East Yorkshire Solar Farm

Landscape & Visual Written Representation

Client: Mr & Mrs Taylor

Issue 2 – 18th June 2024

Number/Figure GLY0042 LV05	Project East Yorkshire Solar Farm
Scale A3	Drawing Title Photographic Views 7 & 8
Date 05/03/2024	Client Mr & Mrs Taylor
Checked APF

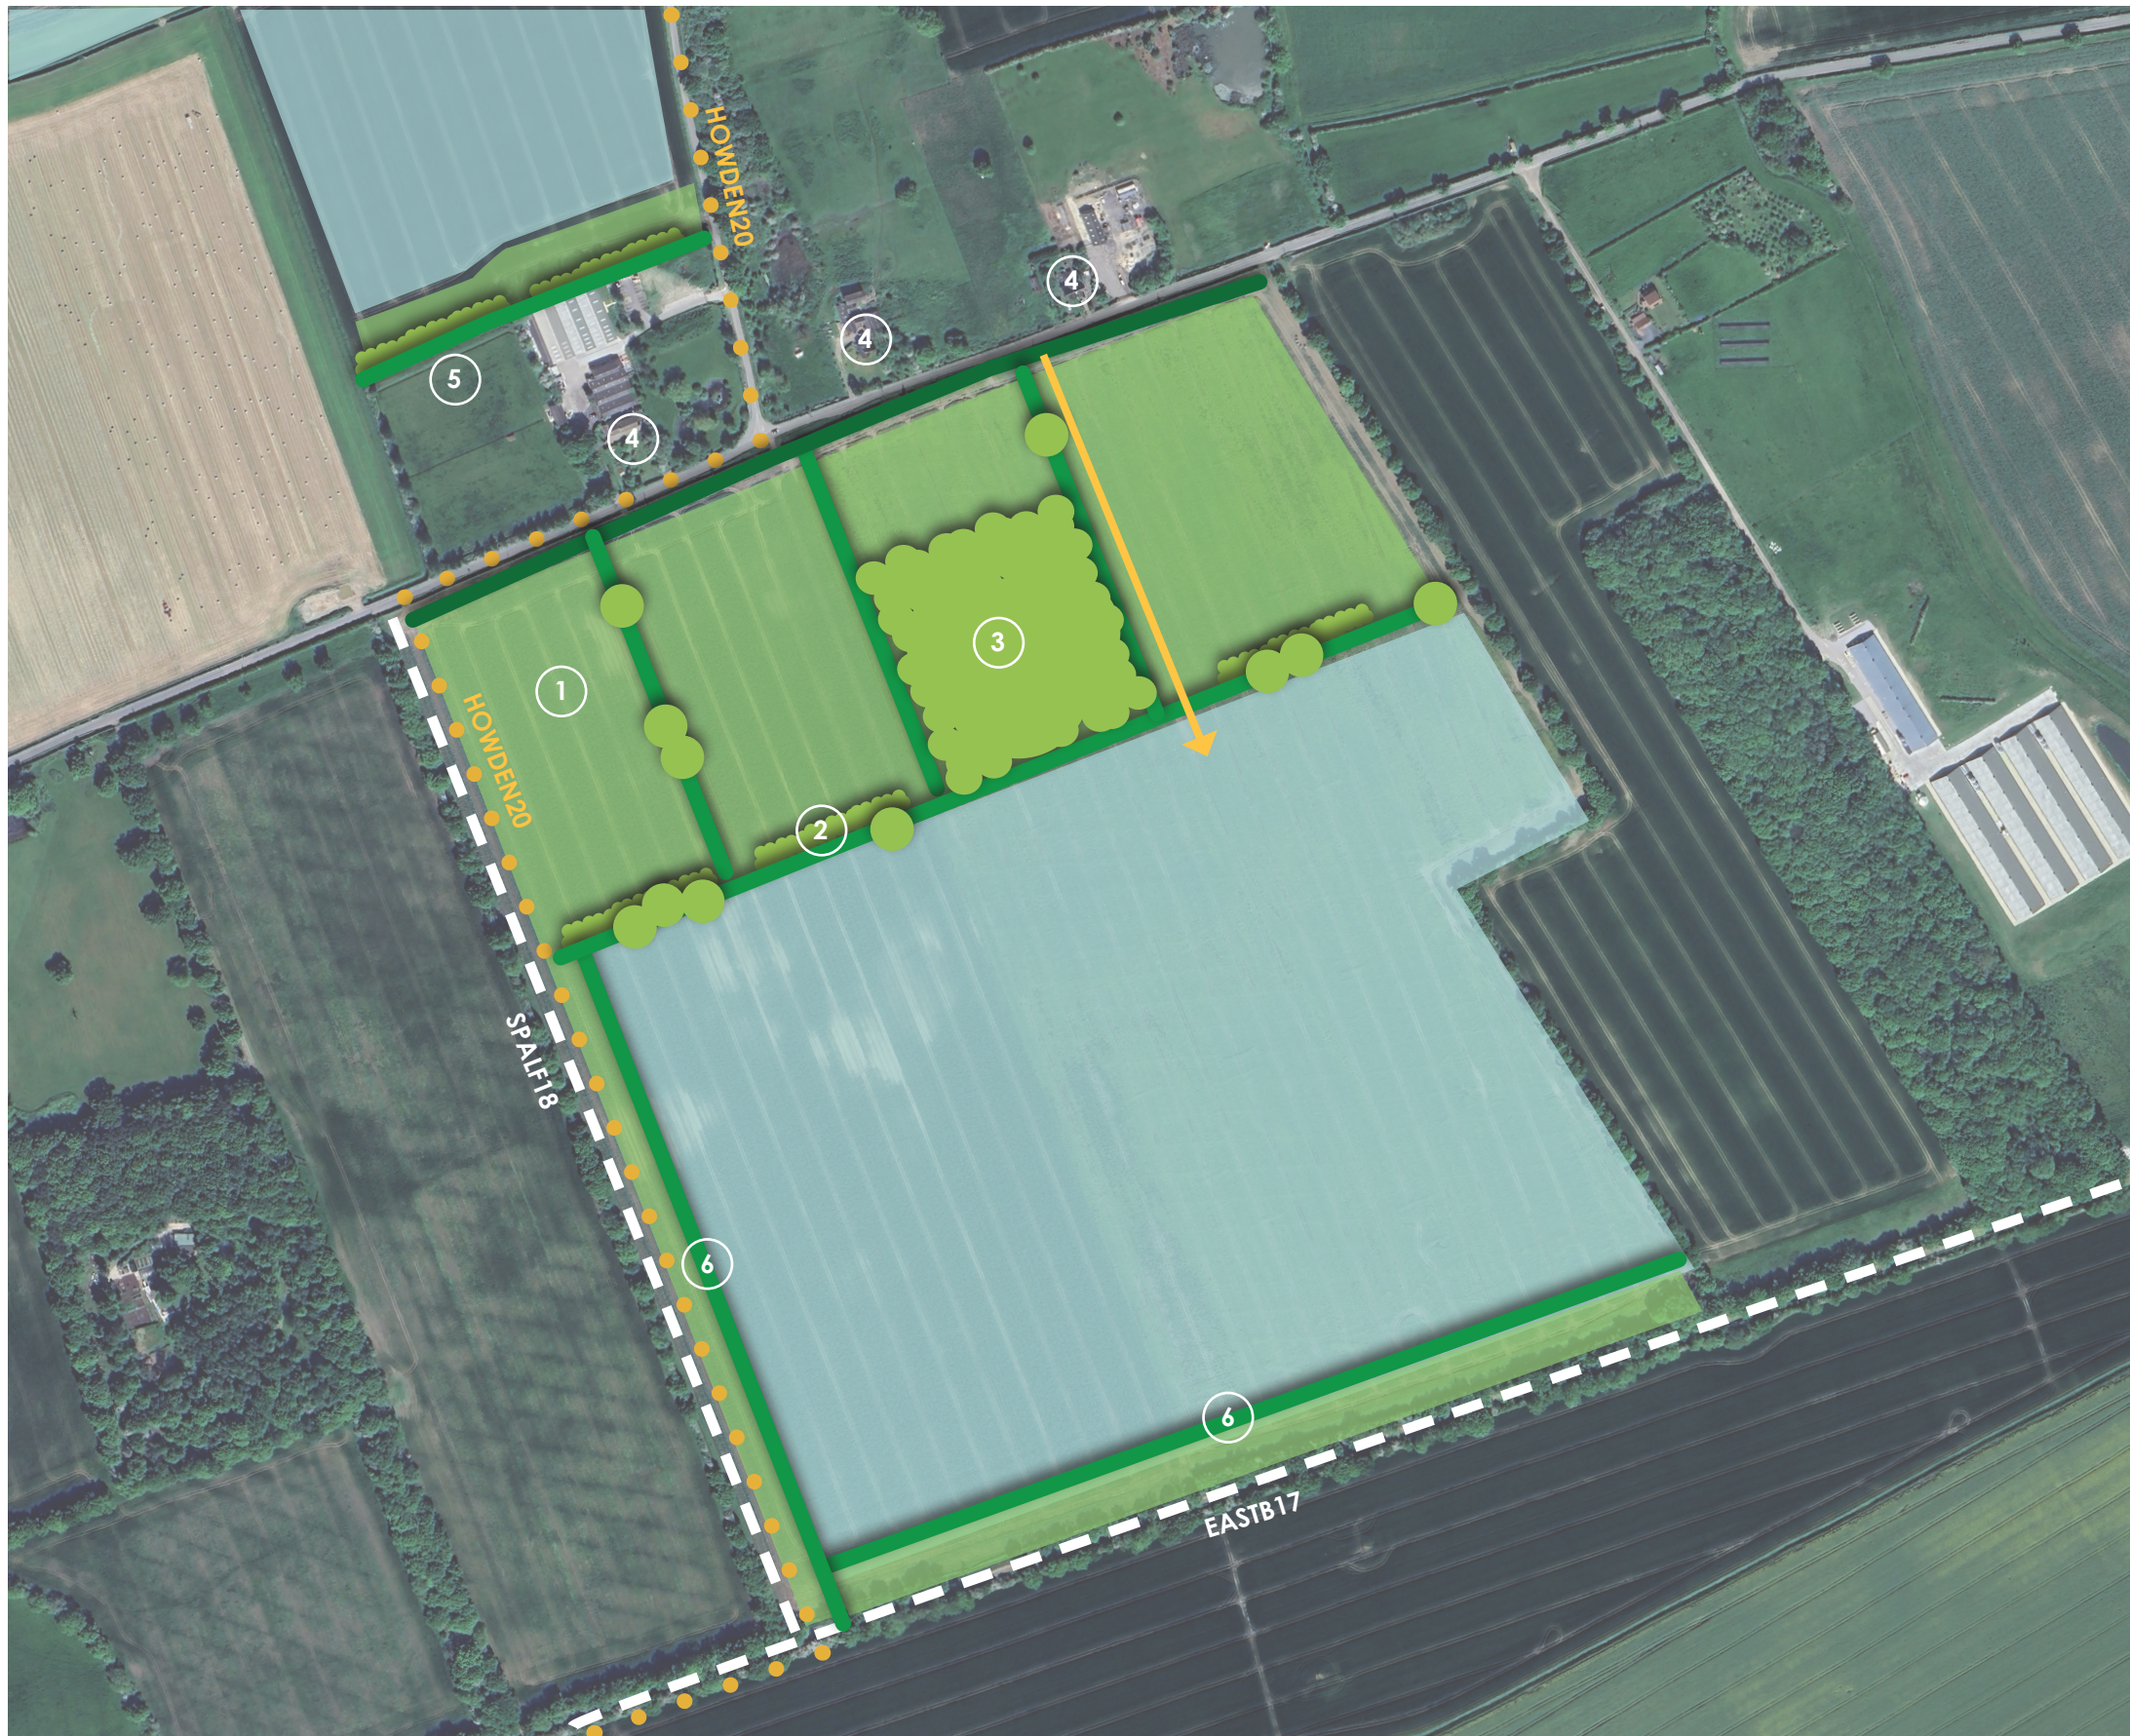
- 3.30 Views 6 and 7 illustrate the open setting of PRoW SPALF18 and route of the Howden20 in this location. The views provide an open appreciation of the large arable field extending south from Spaldington Road (area 2f) together with mature tree, woodland and hedgerow cover at its boundaries. Broad treed skies characterise the views and are again representative of the expansive views that characterise the local landscape.

- 3.31 Views 6 to 8 are experienced by users of SPALF18 and the Howden20 that are of high sensitivity. This is reflected in the assessment of Viewpoint 4 in the ES which also confirms these receptors are of high sensitivity.
- 3.32 In summary, the visual setting of Area 2f in particular, and that of [REDACTED] Sandwood Cottage or Sandwood Villas, is experienced principally by receptors of high sensitivity, together with receptors of medium to high sensitivity on Spaldington Road. Chapter 10 of the ES does not consider views northward from equestrian land associated with [REDACTED] that are also of high sensitivity.

- 5.11 The same effects are likely to be reported to users of SPALF18 and the Howden20 at the west of area 2f. This representation has provided views 6 and 7 to illustrate the visual setting of SPALF18 and the Howden20; see **GLY0042 LV04 and LV05**. These demonstrate the substantially more open visibility of area 2f that would clearly also result in a high magnitude of change in Year 1, reducing to medium in Year 15 if effective mitigation planting was adopted along the entirety of its western edge. When applying the ES methodology, a significant moderate adverse effect is therefore also likely to persist in the long-term.

See GLY0042 Landscape & Visual Written Representation for full details of proposed mitigation and 1855 Ordnance Survey extract.

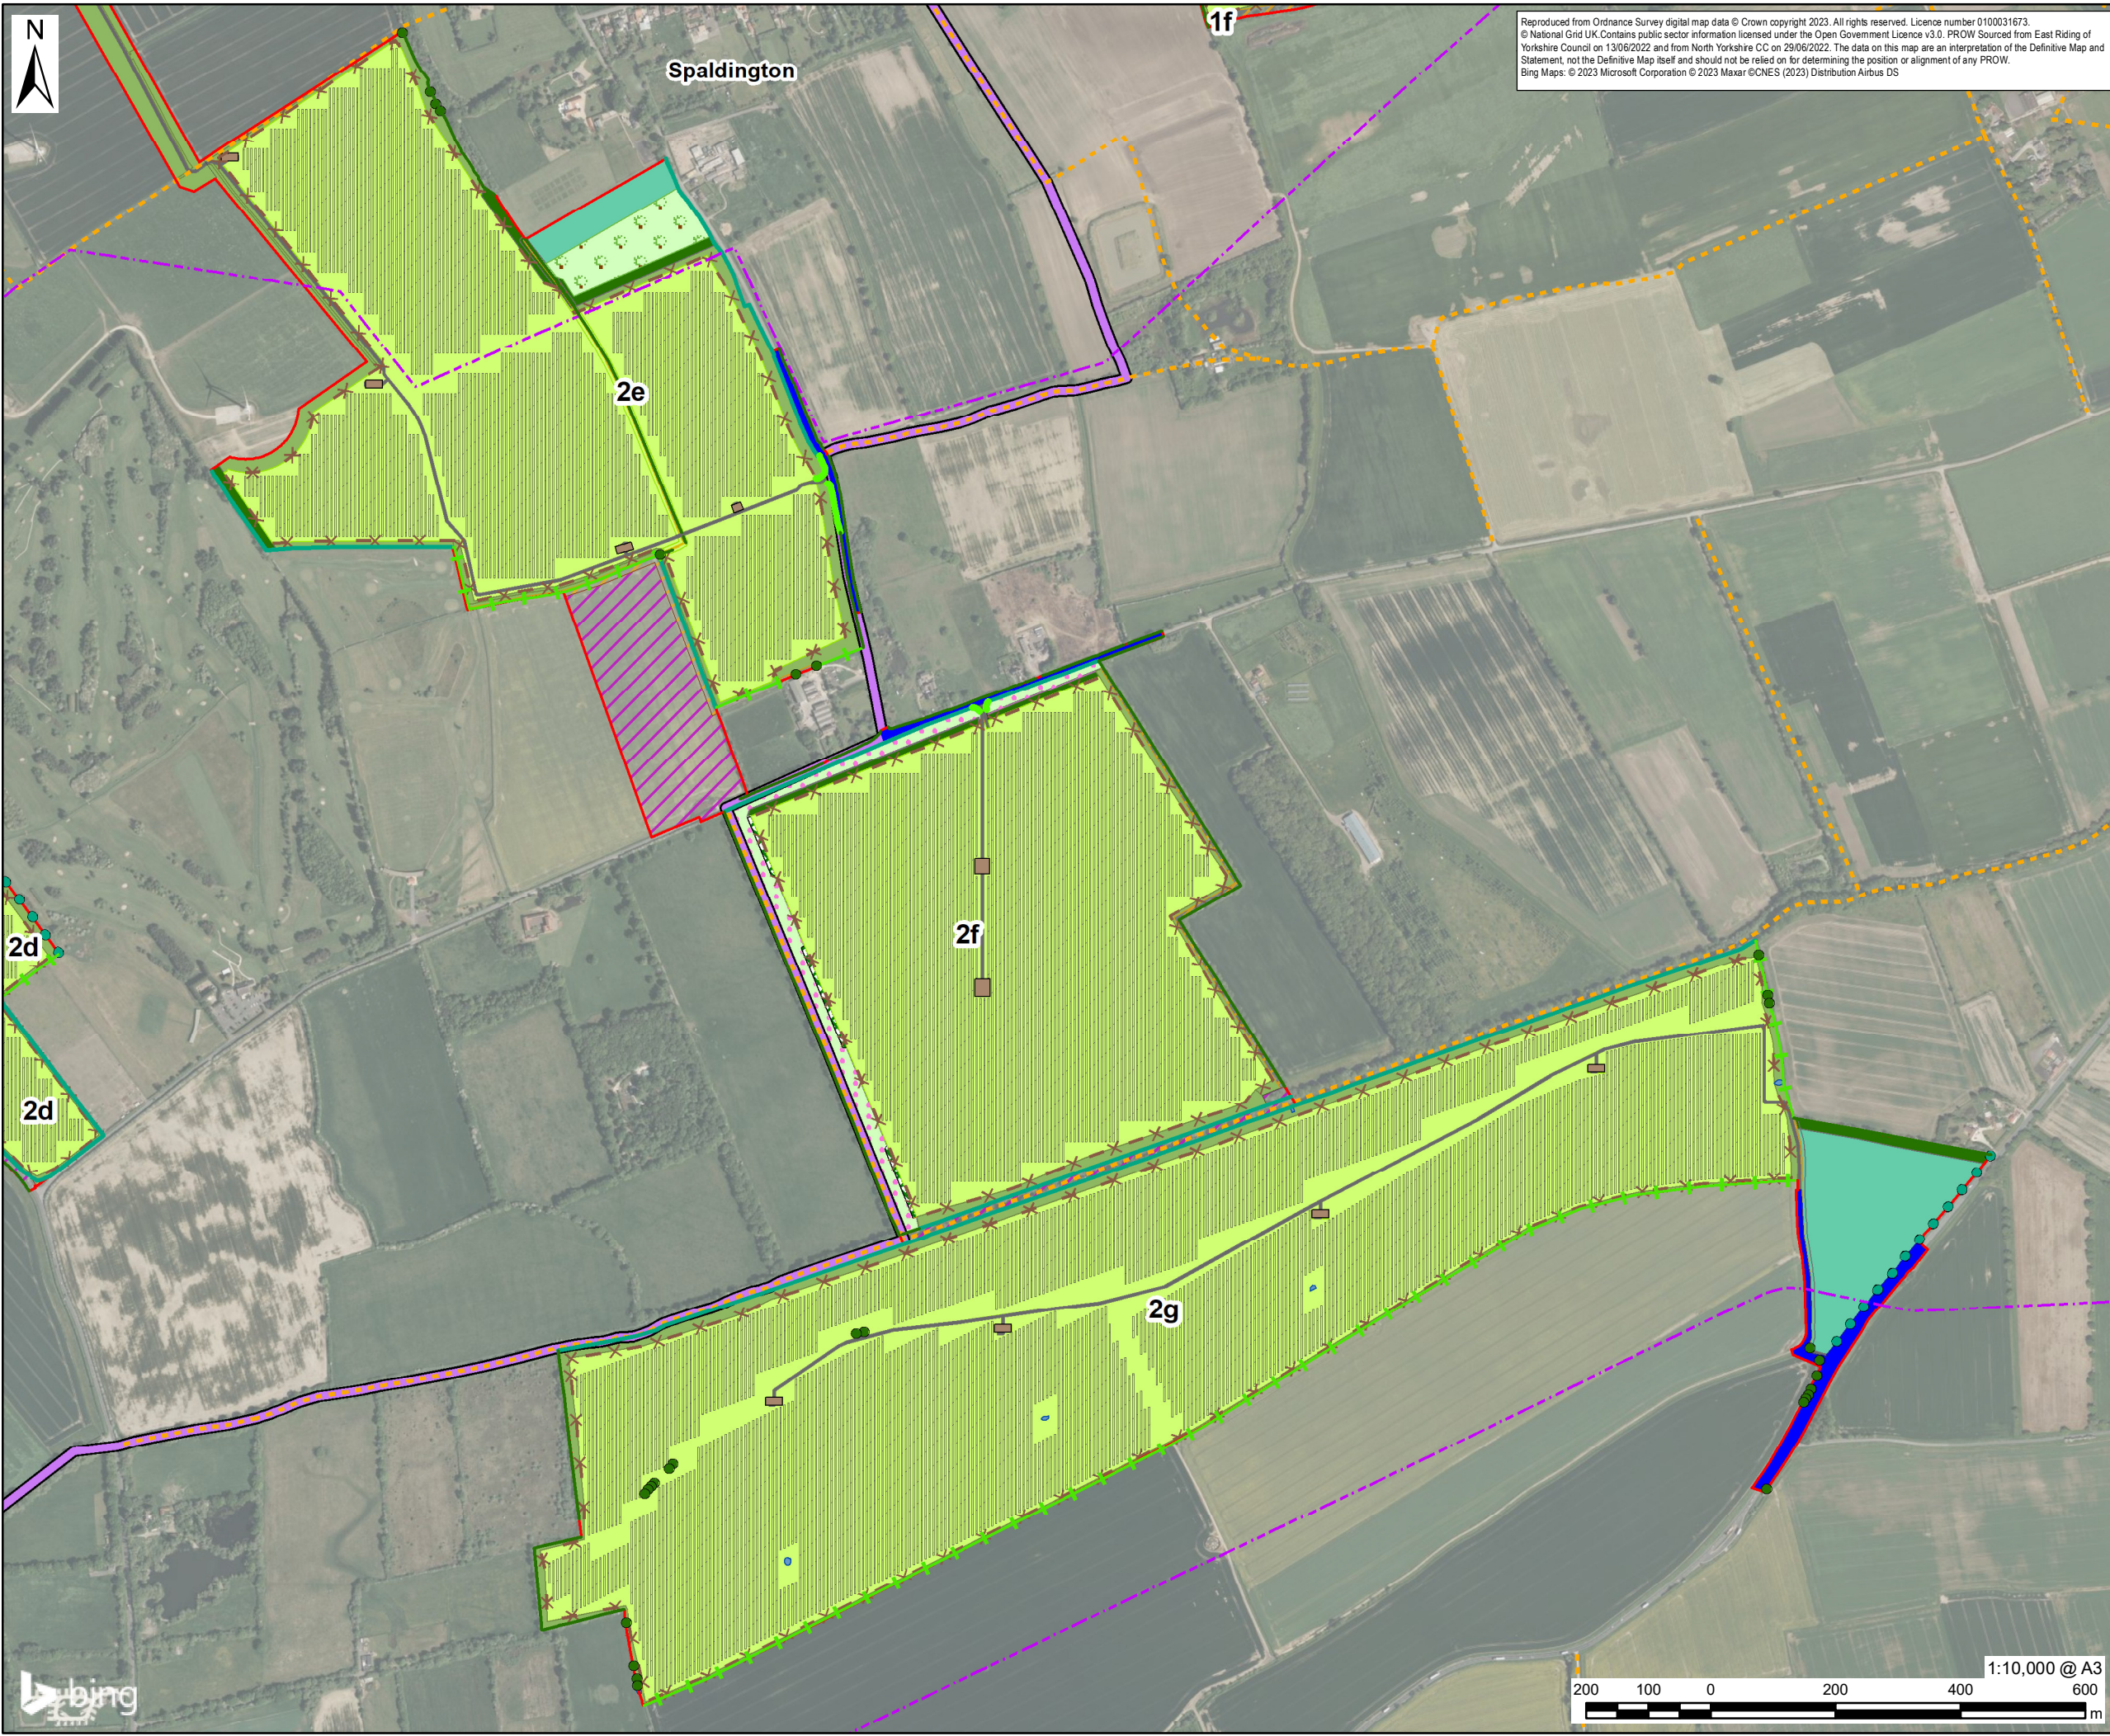
- 6.4 A Landscape Mitigation Plan has been prepared to outline the proposed modifications to area 2e and 2f. This adopts a simple and logical approach:

- 1) Restore – a framework of historic field boundary and woodland restoration to **restore** landscape character, in accordance with the recommendations of GLVIA3.

- 2) Respect – a 'one field buffer' and spatial primary mitigation measure that **respects** and maintains part of the the open character and distant views of Spaldington Road, part of SPALF18 and the Howden20, in accordance with the objectives of NCA39 and LCA 5A.

- 3) Reduce – a framework of secondary planting measures that will complement spatial buffers to **reduce** residual adverse landscape and visual effects.

- 1** Proposed reinstatement of historic field pattern and maintenance as grassland or arable crop for ecological mitigation and to retain an open setting to Spaldington Road.
- 2** Proposed hedgerow reinforced with native scrub to provide meaningful visual buffer over distance.
- 3** Partial reinstatement of Sandpit Wood, creating a characteristic woodland block that buffers the array while retaining a sense of openness.
- 4** Retained open land to the south of the road reduces the overdominance of the array and contributes to respecting open skyline views from the road and residential properties.
- 5** Proposed native scrub planting and hedgerow trees providing a visual buffer to the array while respecting open skyline views.
- 6** Hedgerows introduced along boundary fencing to provide effective visual mitigation.
